HARTZELL PROPELLER INC.
SERVICE LETTER

HC-SL-61-368

Introduction of Redesigned Propeller Hubs

**Redesigned Hub Units
Figure 1**

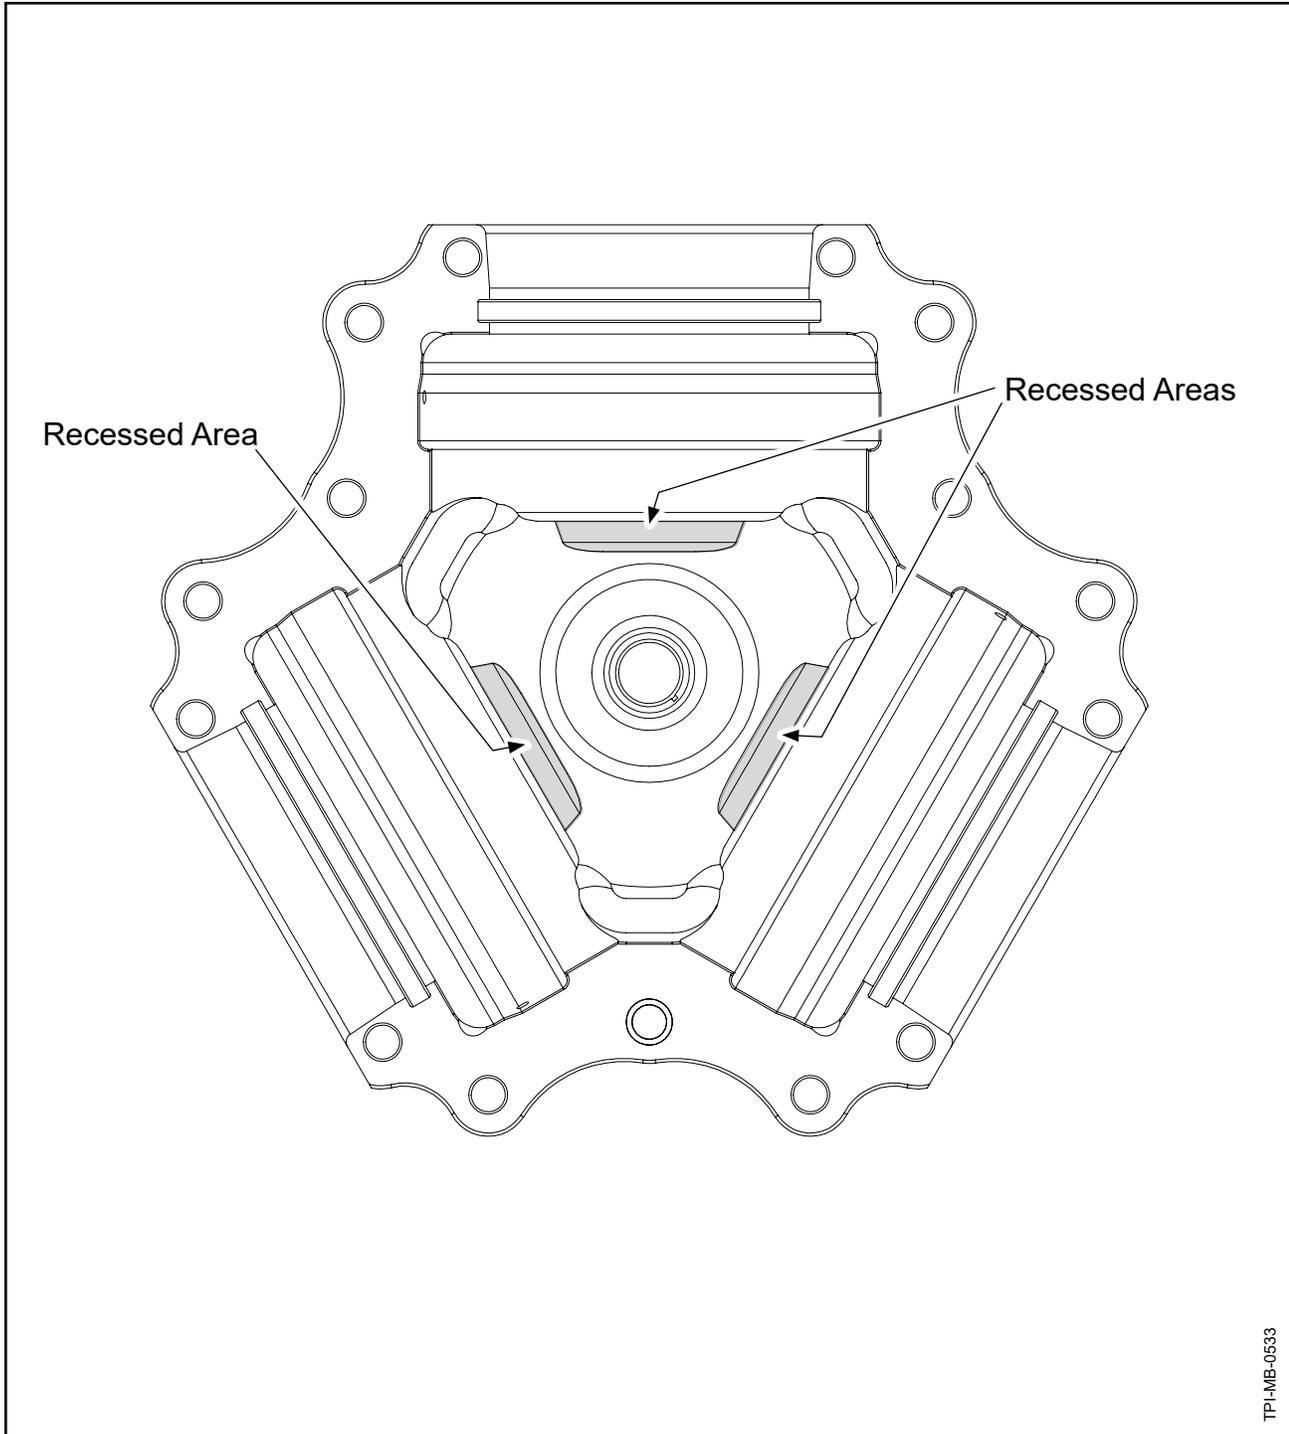
- (1) Hartzell Propeller Inc. has received reports of the pitch change bracket mounting bolts causing damage to the central web area of the hub on affected propellers that have 7690 or 7890 blades installed.
- (2) Hartzell Propeller Inc. has redesigned the hub units used on the affected propellers.
 - (a) The redesigned hub units have recesses in the central web area to eliminate interference with the pitch change knob bracket mounting bolts. Refer to Figure 1.

NOTE: Hub units with revision levels prior to the redesign can be machined to add the recessed areas shown in Figure 1. Refer to Table 1 in this Service Letter for the revision levels of the redesigned hub units.

- (1) The Aluminum Hub Overhaul chapter of Hartzell Propeller Inc. Standard Practices Manual 202A (661-01-02) provides instructions to machine the recessed areas shown in Figure 1 into the central web area of hub units that were manufactured prior to the redesign.
